SUBJECT: REPORT OF TRIP TO ALDEN LABORATORY ON JANUARY 17 AND
18, 2006, TAC NO. MC8434

A meeting was held at Alden Research Laboratory, Inc. on January 17 and 18, 2006 to obtain information pertaining to the review of the application of the Caldon Checkplus ultrasonic flow meter for a power uprate at the Seabrook nuclear power plant. My trip report covering this meeting is provided in the enclosure.

Meeting at Alden Research Laboratory, Inc. On January 17 and 18, 2006 to Review Application of the Caldon Checkplus Ultrasonic Flow Meter (UFM) for a Power Upate at the Seabrook Nuclear Power Plant

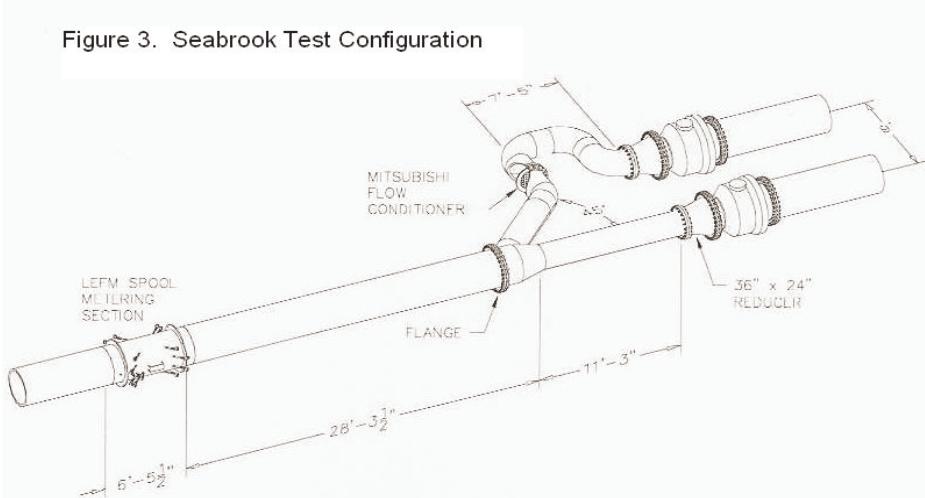
The Alden test configuration for the Seabrook tests is shown in Figure 3. Flow is from right to left with two 24 inch pipes connecting to a 36 inch pipe that contains the CheckPlus UFM.

A cursory review of the configurations, data, and supporting information lead to the following preliminary conclusions:

1. Seabrook's specifications for the Checkplus are 16,400,000 lbs/hr @ 447 °F (Reference D). This corresponds to close to 40,000 gpm or 20,000 gpm per feedwater train. With the exception of Test B-4 with full flow through the half-moon, the B series tests are with flow rates of roughly half what Seabrook specified for total flowrate capability. This is an open item that we are reviewing.

2. Water temperature during the tests was approximately 95 °F. The operational specification is 447 °F. This is an open item that we are reviewing.
3. Test A-1 covers the extreme condition of feedwater limited to one feedwater path. The full flow test through the half-moon covers the extreme condition of feedwater from the other feedwater path with the additional complication of introduction of swirl. These bracket the operational configurations that will be encountered during plant operation.

Figure 4. Sketch of Velocity Measurements

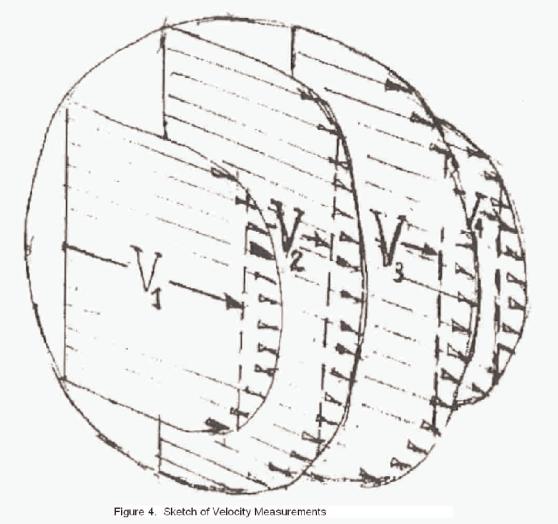
The Caldon UFM provides either four or eight average velocities as illustrated in Figure 4 for the four velocity design. Caldon then defines a "Flatness Ratio" (FR) as the sum of the outer velocities (V_1 and V_4) divided by the sum of the inner velocities (V_2 and V_3) for the four path UFM, with a similar definition for the Checkplus eight path UFM. It uses this parameter to assess UFM behavior and to address characteristics under different flow conditions. With this approach, for example, Reynolds number extrapolations are no longer used.

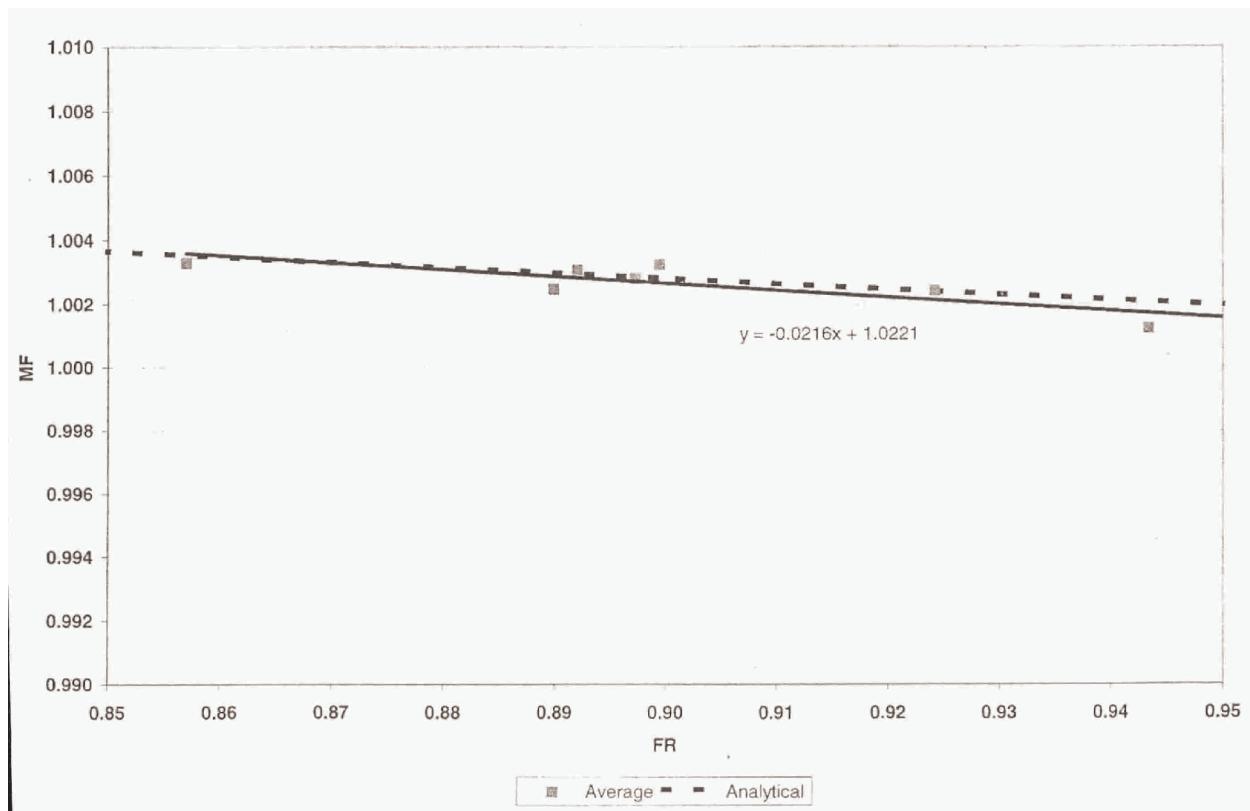
Caldon uses the Checkplus output to compensate for flowrate changes and swirl and no longer uses a Reynolds number extrapolation to extrapolate UFM correction factor to plant conditions. This approach appears promising but I have not completed my evaluation of these processes and have not reached any findings. Consequently, there is little coverage of these topics in this report.

As a further example, preliminary test results are provided in Figure 5 that show correction factor (that Caldon defines as MF) as a function of FR for a range of conditions. Further, Caldon has also used Checkplus results to determine the influence of swirl on correction factor.
